Modification to observed pointing wobble during staring observations

Issued: 21 October 2010

Comparison of relative flux variation with time for two staring observations of HD 158460. The black curve is the data from the pre-change AOR (40837888). The green curve is the data from the post-change AOR (40838144). Each data set has been boxcar smoothed using a window of 101 samples.

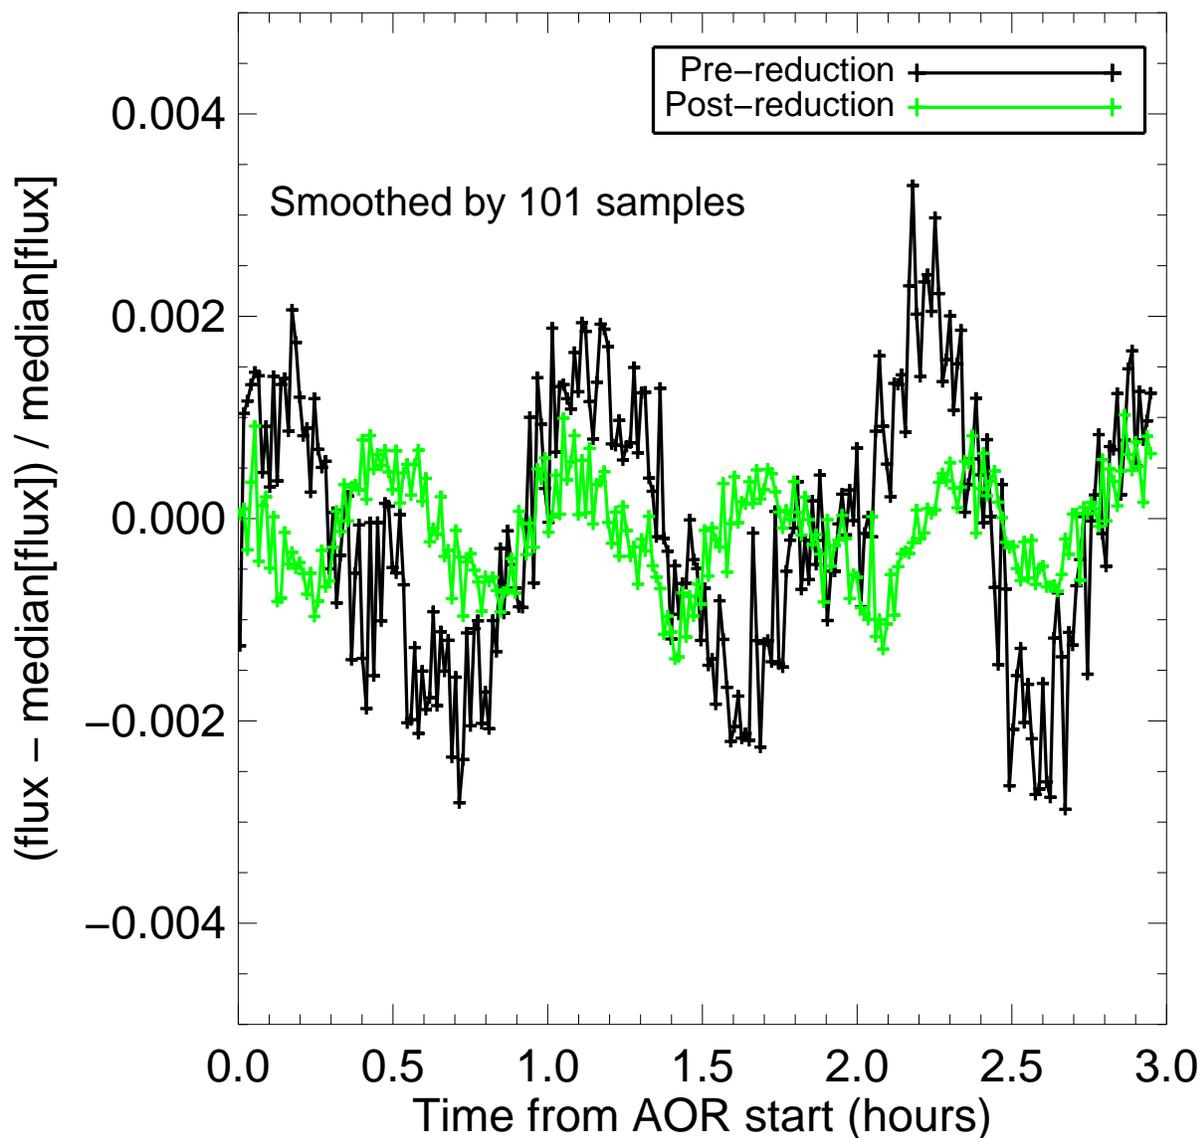
The SSC has performed a preliminary analysis of the data and finds that the photometric variations associated with the pointing wobble are reduced. The period of the pointing wobble after the heater cycling change is estimated to be 36 minutes from a periodogram analysis of the measured stellar centroids. It is possible that this period will change (decrease) as a new equilibrium is reached with the implementation of the heater cycling change.

No additional structure is noted in the light curve. After fitting for the pixel-phase effect using a 2nd order polynomial in ΔX , ΔY (relative centroid position), the signal-to-noise of the pre-change data is 444.3 per exposure, the signal-to-noise for the post-change data is 463.2, while the theoretical signal-to-noise for the observations should be 533.6. That is, the pre-change SNR is 80% of the ideal, and the post-change is 84% of ideal. This initial analysis suggests that the precision of the binned data after the change is even better. A more in-depth analysis will be presented in an upcoming memo.
